Appendix 1 – Consultation on the proposed DCO Amendment

Appendix 3 – Latest site Illustrative masterplan (Ref. NGW-PHP-00-00-DR-A-4054-001-P27)

Appendix 5 – Proposed revised Parameters Plan (Doc 2.10 Ref. 4054-R007 – Rev S4)

Appendix 6 – Transport Technical Note (by ADC Infrastructure)

Figure 7: proposed partial signalisation of the A508 site access junction

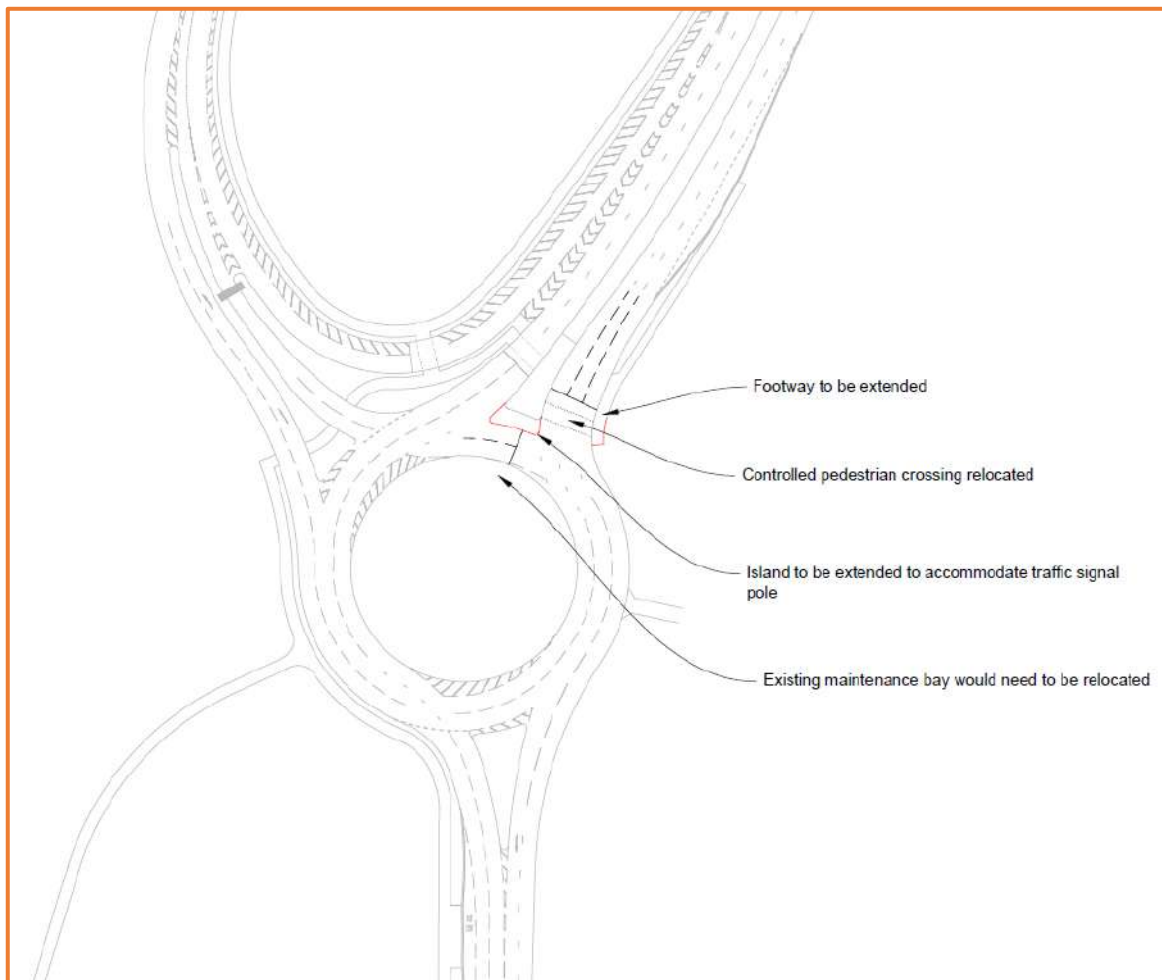
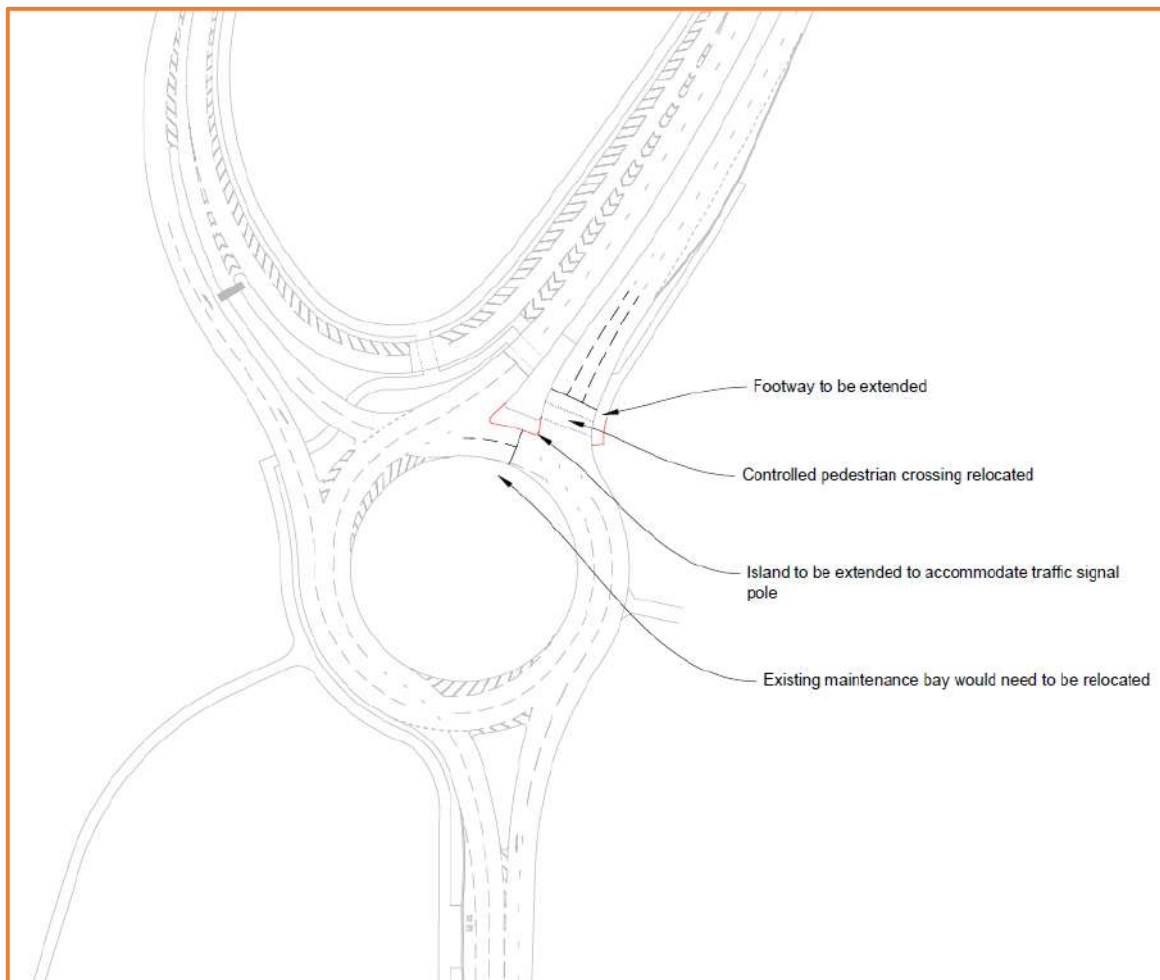
2.	<p>Model Structure: The northern circulatory (Arm 7), adjacent to the A508 Southbound approach, only shows a single lane. However, but Figure 7 in the “DCO Amendment” report shows it as two lanes. Is there a reason for modelling the arm in that way?</p>	<p>The right-turn flow from the site is relatively low and hence was modelled in a single lane for simplicity. However, the model has been amended to show two lanes.</p>
	<p>The site access arm (Arm 6) does not show the two lanes that enter the roundabout, but just a single lane (Arm 6, lane 2). Please can you explain why it has been modelled as a single lane?</p>	<p>As above.</p>
	<p>The LinSig model does not include the pedestrian crossings located on the A508 Northbound exit and the left turn on the site access arm. Please can you justify the exclusion of these two crossings from the model?</p>	<p>These crossings would be called infrequently and would not impact on the overall performance of the junction.</p>
